## Access Compliance Report Public Rights-of-Way (Curb Ramps)

Intersection ID: 30001 Main Street: BACKWATER\_DR Cross Street: CORBETT\_SQUARE\_LN Location: E

ADA ID: 7A9BF67A16EA Ramp Type: PerpDiag Initial Pass/Fail: Fail Overall Compliance: No Severity Score: 46.25

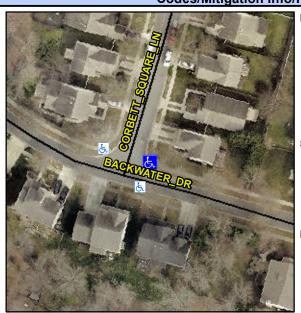
Not Found, R304.5.1, R304.2.2, R304.5.3

Field Measurements/Component Compliance					
Compliance Description		Data	Com	oliance Description	Data
N/A	Ramp Length (in)	63.0	No	Ramp Slope (%)	8.5
No	Ramp Width (in)	47.0	No	Ramp XSlope (%)	7.0
N/A	Flare Type LT	N/A	N/A	Flare Type RT	N/A
N/A	Flare Slope LT (%)	N/A	N/A	Flare Slope RT (%)	N/A
N/A	Flare Traversable LT?	N/A	N/A	Flare Traversable RT?	N/A
N/A	Landing Length (in)	N/A	N/A	DWS Provided?	N/A
N/A	Landing Width (in)	N/A	N/A	DWS Contrast?	N/A
N/A	Landing Slope (%)	N/A	N/A	DWS Length (in)	N/A
N/A	Landing X Slope (%)	N/A	N/A	DWS Full Width?	N/A
N/A	Landing Curb? (Y/N)	N/A	N/A	DWS Offset (in)	N/A
N/A	Shared Landing?	N/A			
N/A	Gutter Ponding?	N/A	N/A	Gutter Slope (%)	N/A
N/A	Gutter Lip Ht (in)	N/A	N/A	Gutter X Slope (%)	N/A
N/A	Painted X Walk1?	No	N/A	Painted X Walk2?	No
	X Walk 1 Direction	To NW		X Walk 2 Direction	To SW
N/A	X Walk 1 Width (in)	N/A	N/A	X Walk 2 Width (in)	N/A
	X Walk 1 Slope (%)	3.2		X Walk 2 Slope (%)	5.0

X Walk 1 X Slope (%)	2.9		X Walk 2 X Slope (%)	5.0
N/A	Ramp inside XWalk1?	N/A	N/A	Ramp inside XWalk2?	N/A
	Road Slope (%)	5.6	N/A	Clear Space?	N/A
	Road X Slope (%)	0.4	N/A	Clear Space to XWalk (in)	N/A
N/A	Any Obstructions?	N/A	N/A	Storm Grate/Utility Hazard?	N/A
	Obstruction Type			Storm Grate/Utility Type	
		N/A			N/A
			Yes	Surface Condition? (G/P)	Good

Remove & Replace Curb Ramp With Two New Directional Ramps or Equivalent.
